SUBJECT: Amendment 7, Approved Conventional Explosives Safety Submission (ESS), Munitions Response (Removal), Eastern Bypass, Fort McClellan, Alabama with Amendments 1 through 6.

Amendment 7
To the Approved Conventional Explosive Safety Submission, Munitions Response
(Removal), Eastern Bypass, Fort McClellan, Alabama

8 September 2006

**Figure 4-1
"Y" Removal Area
Overview**

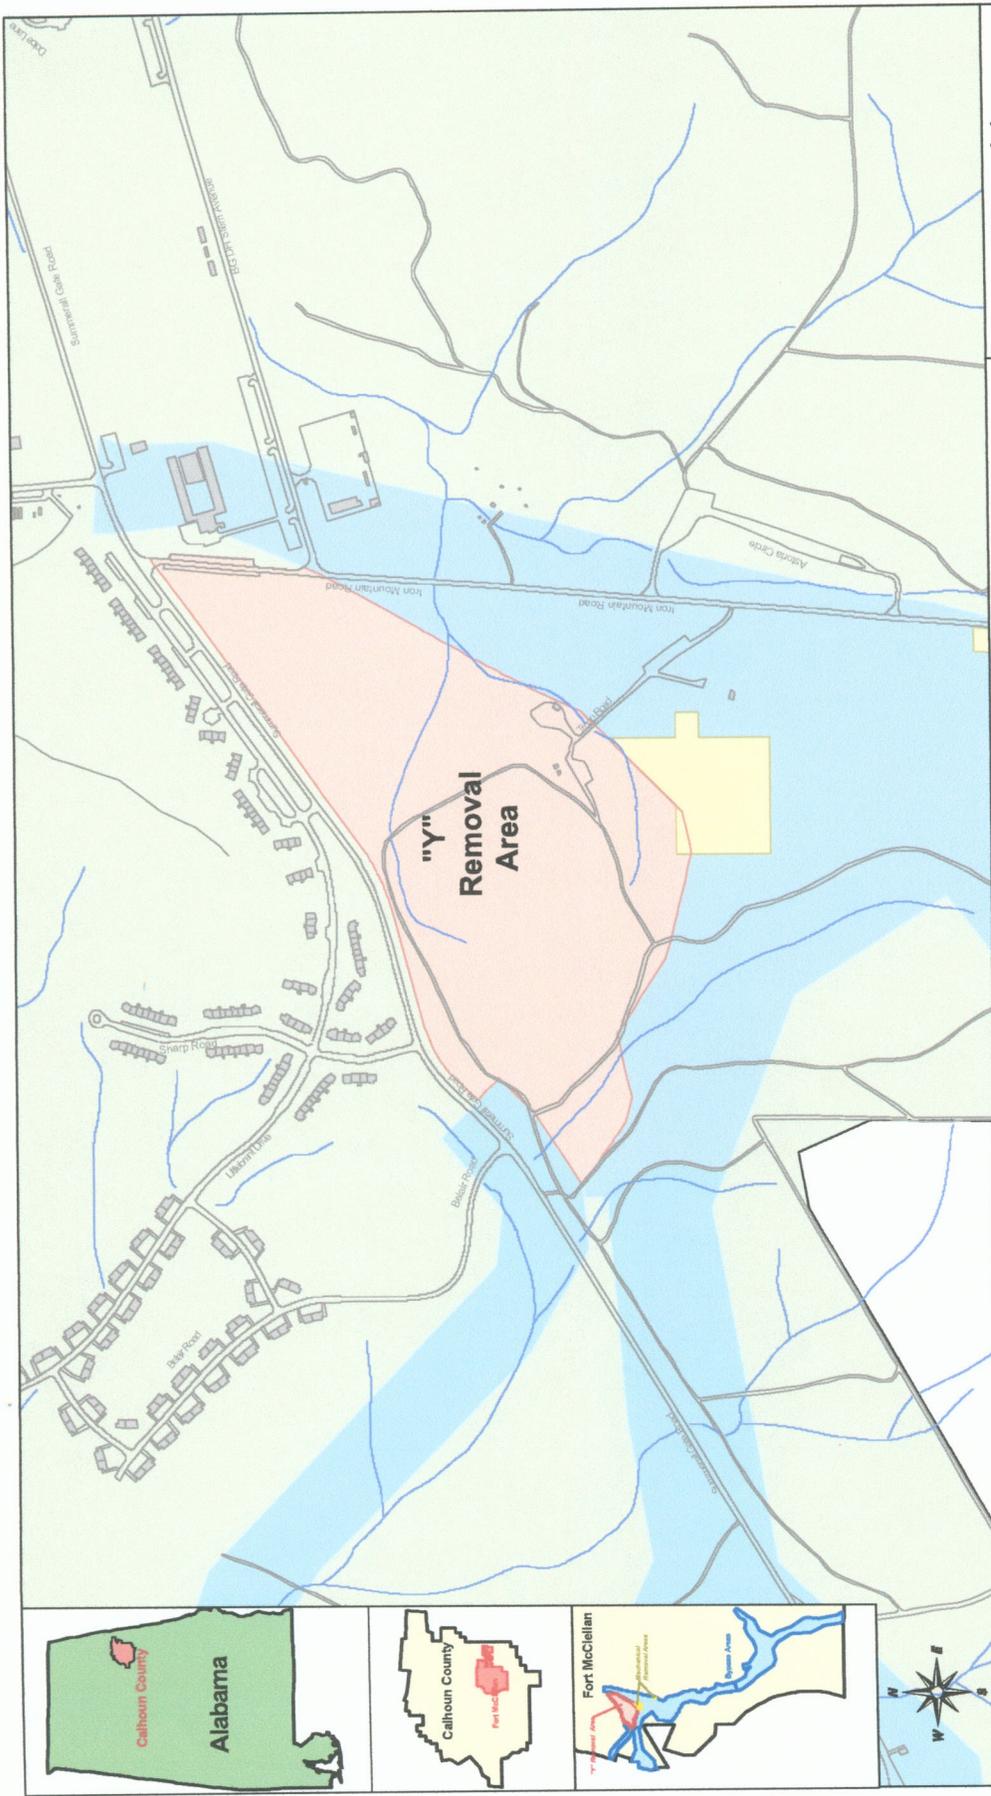
1.7 Amendment 7 requests the withdrawal of the requirement for education of construction workers in the “Y” area (see Figure 4-1, “Y” Removal Area Overview). This amendment provides justification for withdrawing this requirement.

This Amendment removes the education of construction workers within the “Y” area (see Figure 4-1, “Y” Removal Area Overview). The remainder of the LUC specified in the original ESS and all previous amendments are unchanged by this Amendment.
